NUCLEAR ENERGY INSTITUTE

**SUBJECT:** Response to Questions on Addendum 2 to EPRI Performance  
Prediction Methodology Software, Version 2.0

**Responses to NRC Comments on  
Addendum 2 to EPRI TR-103237-R2**

**Figure B-1.** Prediction Ratio (PR) versus Allowable Rate-of-Loading (ROL) for Cold Water Strokes

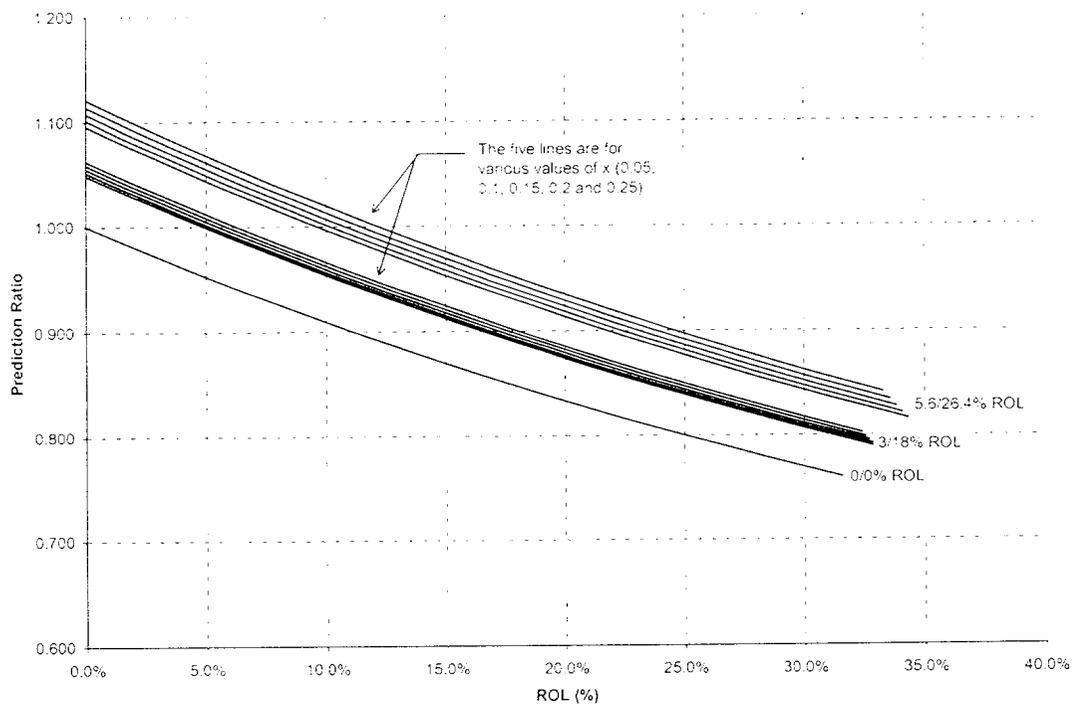
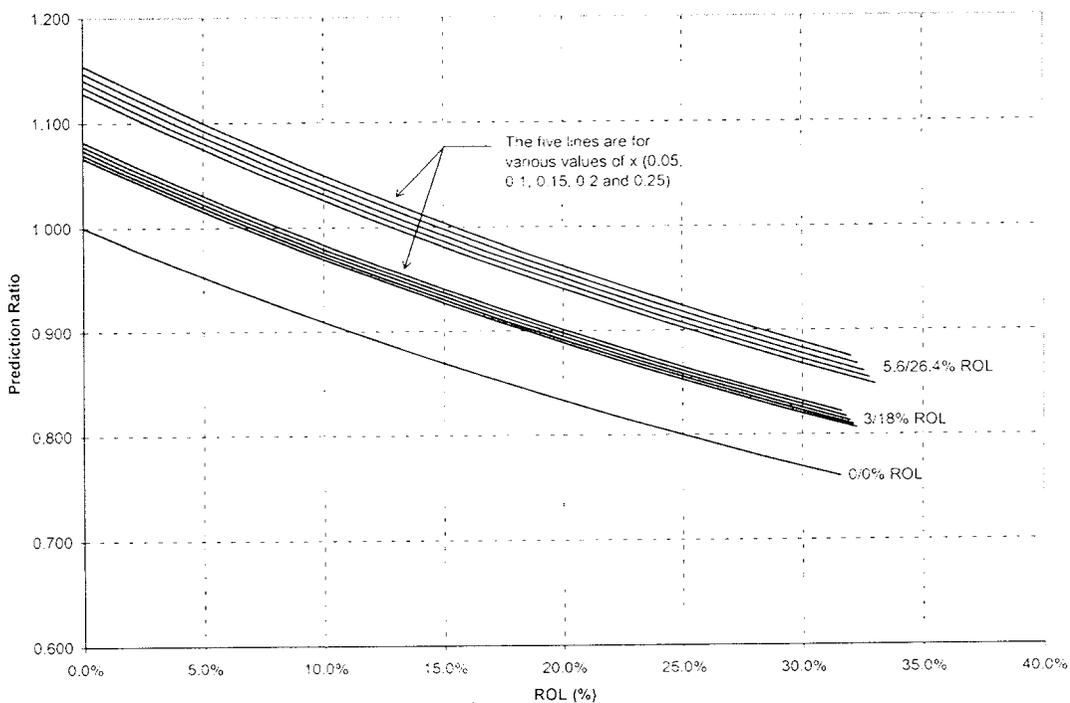
Explain the basis for comparing a prediction ratio based on dynamic thrust predictions from the EPRI MOV PPM to a prediction ratio based on thrust predicted to be delivered at torque switch trip (including random and bias uncertainties) to support the Thrust Uncertainty Method.

Figures B-1 and B-2 plot PR versus available  $\text{ROL}_{\text{margin}}$  for ROL values of 5.6/26.4%, 3/18% and 0/0% bias/random, for cold water strokes and hot water strokes, respectively. The five different lines for 5.6/26.4% and 3/18% ROL correspond to  $x$  values of 0.05, 0.10, 0.15, 0.20 and 0.25. These plots use the  $T_{\text{CST}}/T_{\text{PPM}}$  values shown in the table above. Using the example above, if  $x = 0.15$ ,  $\text{ROL} = 5.6/26.4\%$ ,  $\text{APR} = 0.697$  (cold water) and PR is 0.9, the amount of ROL that can be tolerated is 23.1%, as shown on Figure B-1.
